**TO:** Development Review Board  
**FROM:** Scott Gustin *SG*  
**DATE:** August 19, 2014  
**RE:** 14-0747SD; 1891 North Avenue

**Request:** Subdivide two lots into three lots, remove existing single family house, construct two duplexes and one single family home

TOM MITCHELL  
RESIDENTIAL SUBDIVISION  
1891 NORTH AVENUE  
STORMWATER/EPSC PLAN  
BURLINGTON VERMONT

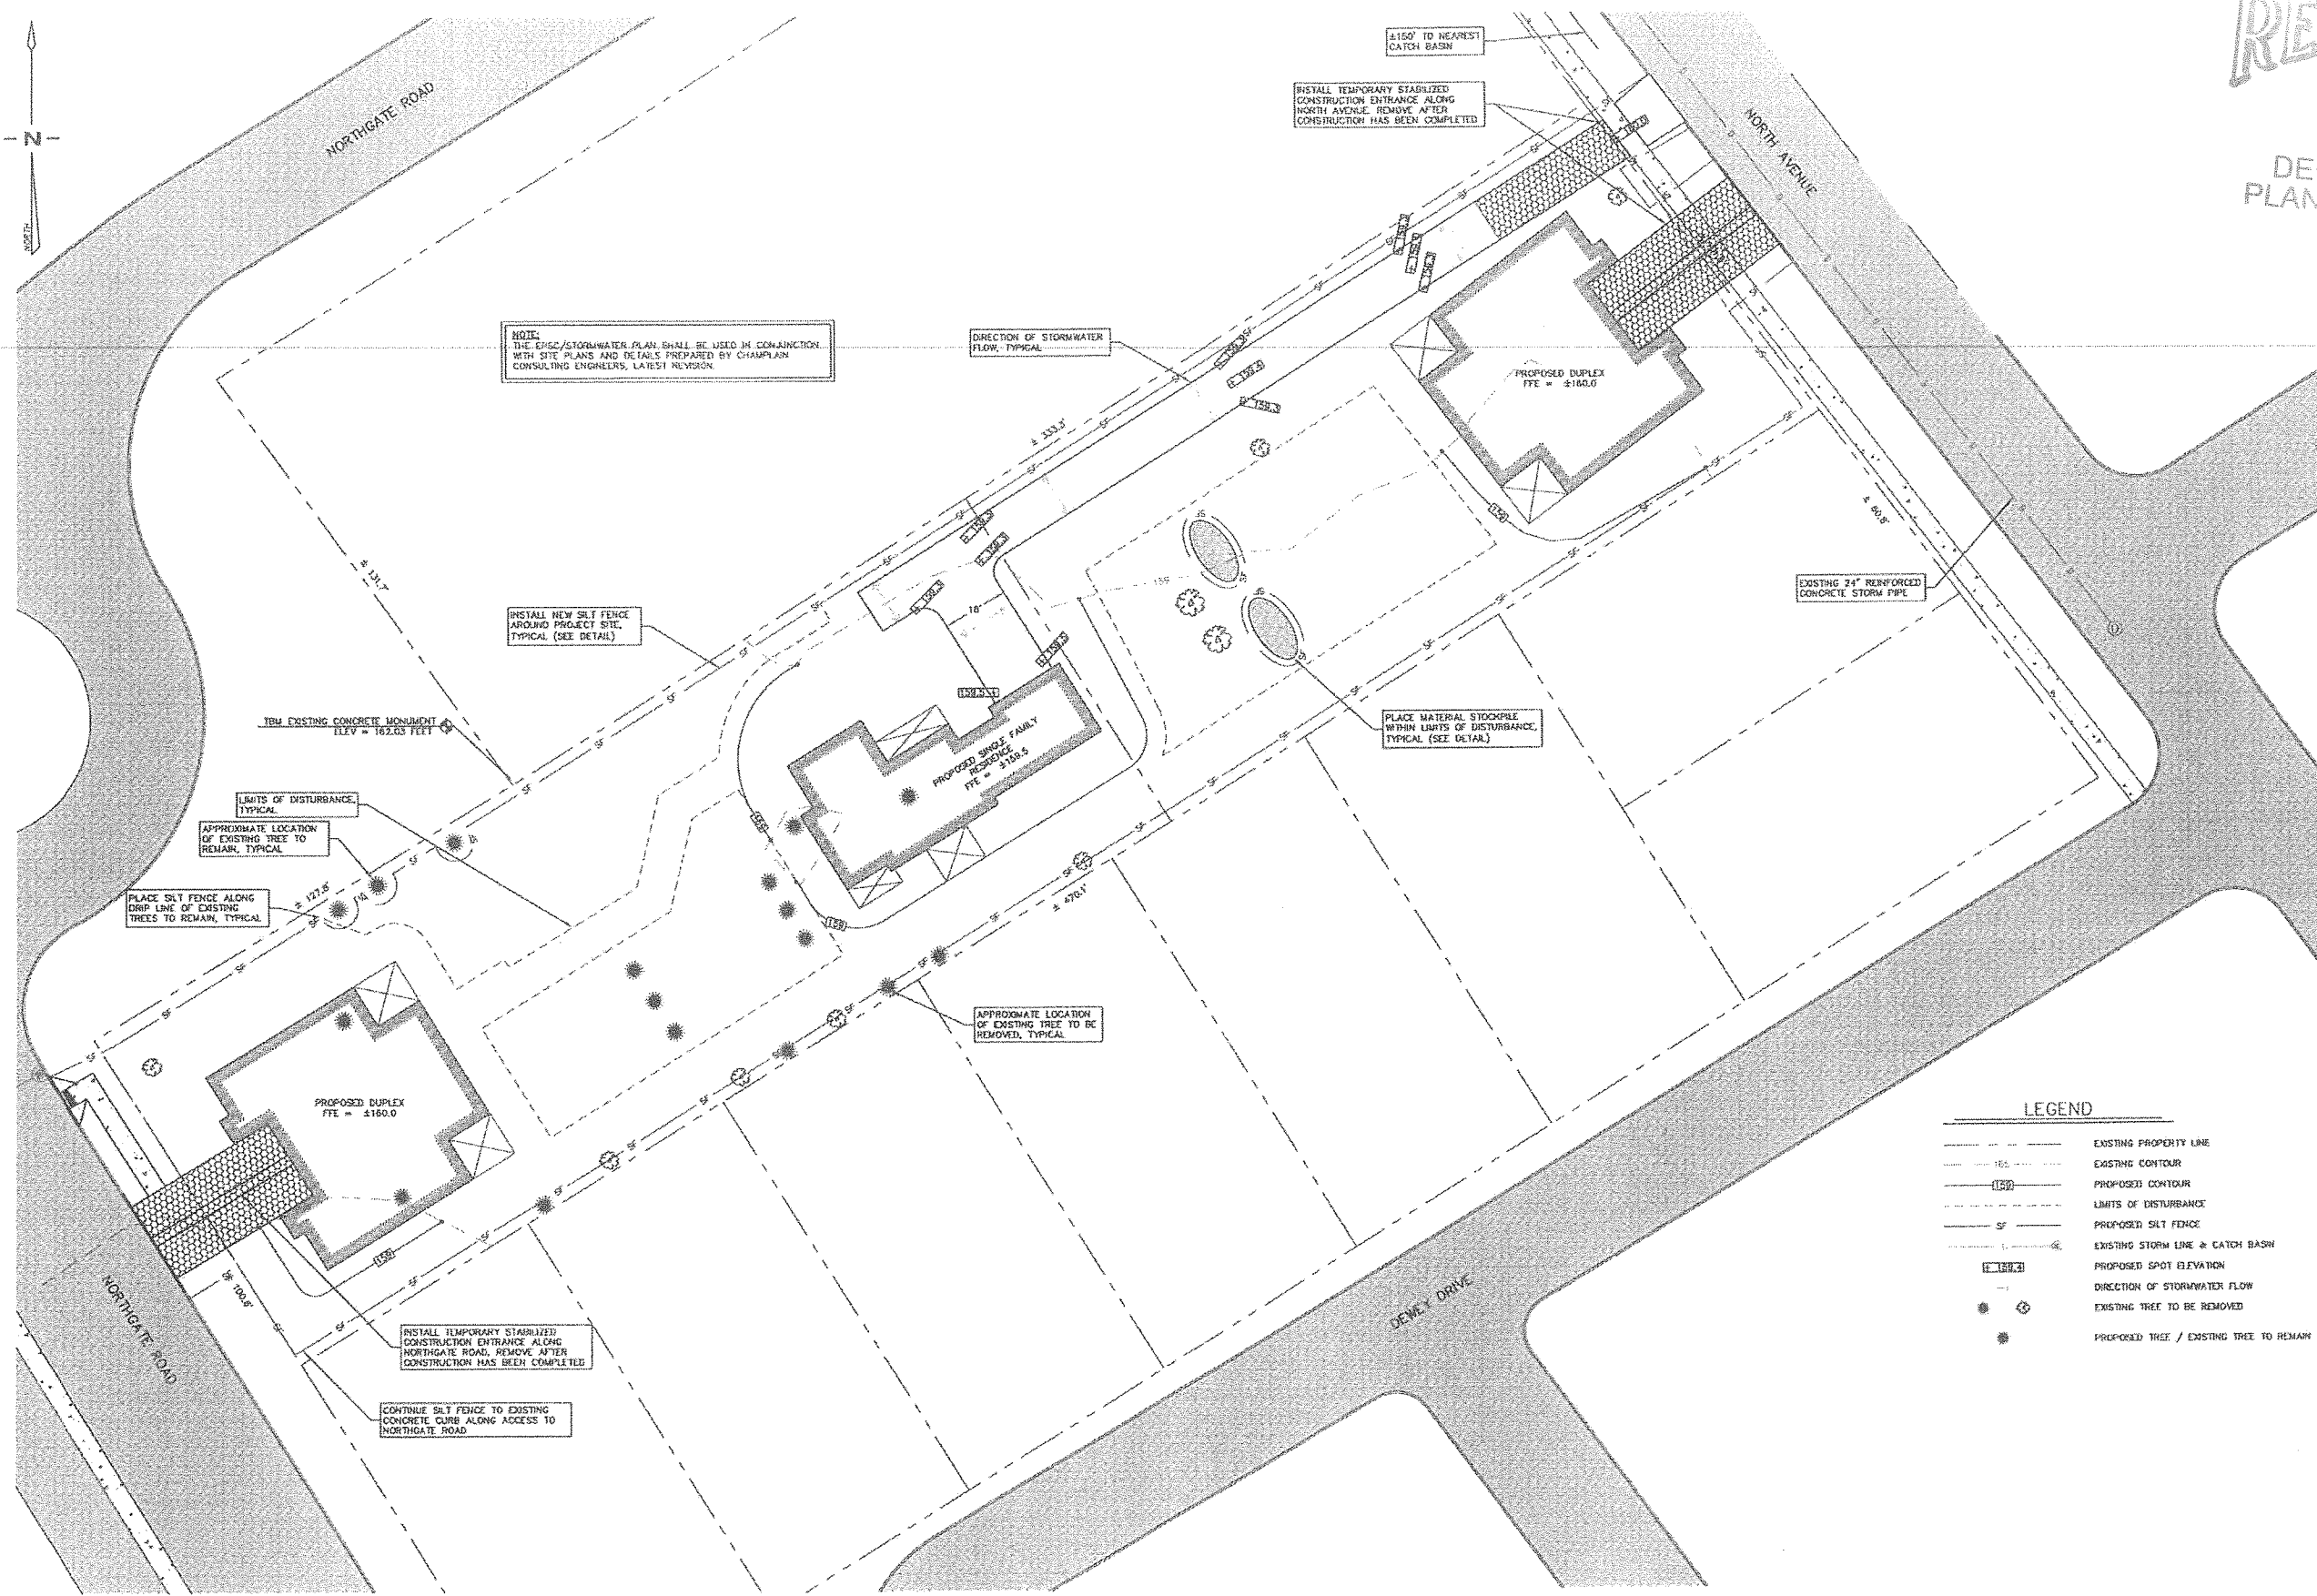
The stormwater management plan has been reviewed and approved by the Stormwater Administrator. Proposed management is simple given the ample green space and very pervious soils. Rooftop runoff will be collected by gutters and dispersed by way of downspouts onto surrounding green space for infiltration into the ground. Driveways will be graded to direct runoff onto adjacent green space for infiltration. No stormwater runoff will be directed into the city system. The construction site erosion prevention and sediment control plan has also been reviewed and approved by the Stormwater Administrator.

The Conservation Board reviewed the proposed stormwater management plan and erosion prevention and sediment control plan on March 10, 2014 and recommended approval of them subject to the standard stormwater and erosion control conditions. **(Affirmative finding as conditioned)**

OUTDOOR LIGHTING by Craftmade

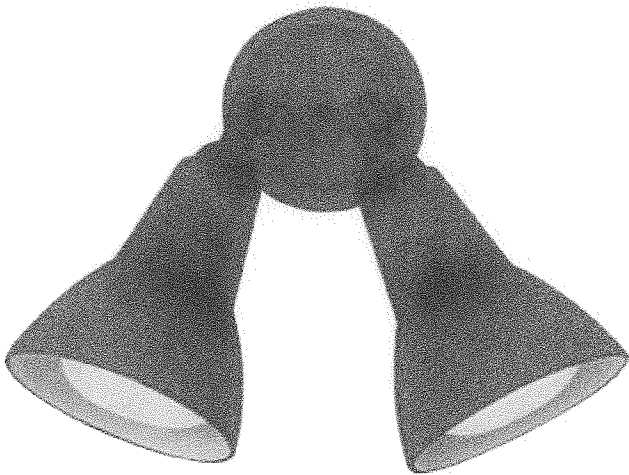
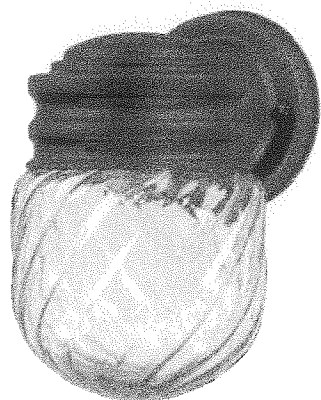
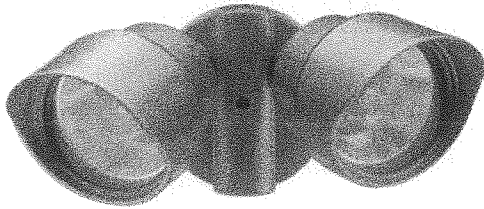
Five types of outdoor lighting fixtures are proposed as options for the new homes (3 lantern type fixtures and 2 spotlight fixtures). All of them use low-wattage bulbs and are likely acceptable. No lumens information has been provided and must be in order to confirm their acceptability. Lumens may not exceed 2,000 to qualify as acceptable low-output lamps. Fixture locations are noted on the site plan but are not depicted on the building elevation drawings and must be. **(Affirmative finding as conditioned)**

2. **Prior to release of the zoning permit**, revised plans shall be submitted subject to staff review and approval. Revised plans shall include:
  - a. Outdoor lighting fixture locations on building elevation drawings;
